## Ardleigh Parish Council Response to National Grid (NG) Scoping Report

# Response to National Grid (NG) Scoping Report<sup>1</sup>

15 November 2022

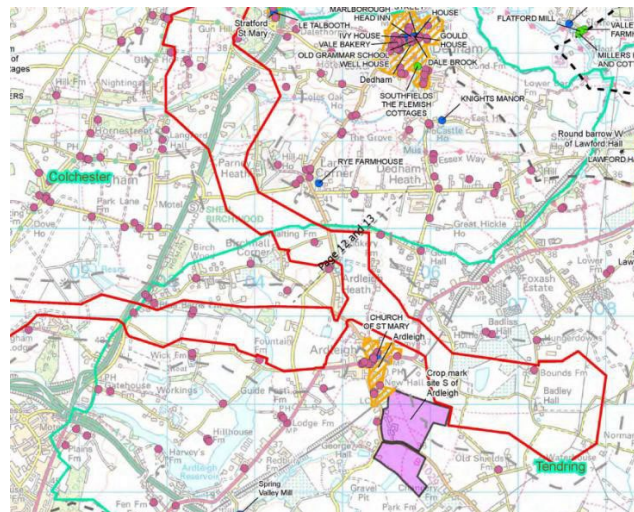
It is imperative, too, that the ES will consider the impact of the doubling back effect of pylons at Ardleigh, which leaves residents living in a 'V' of pylons:
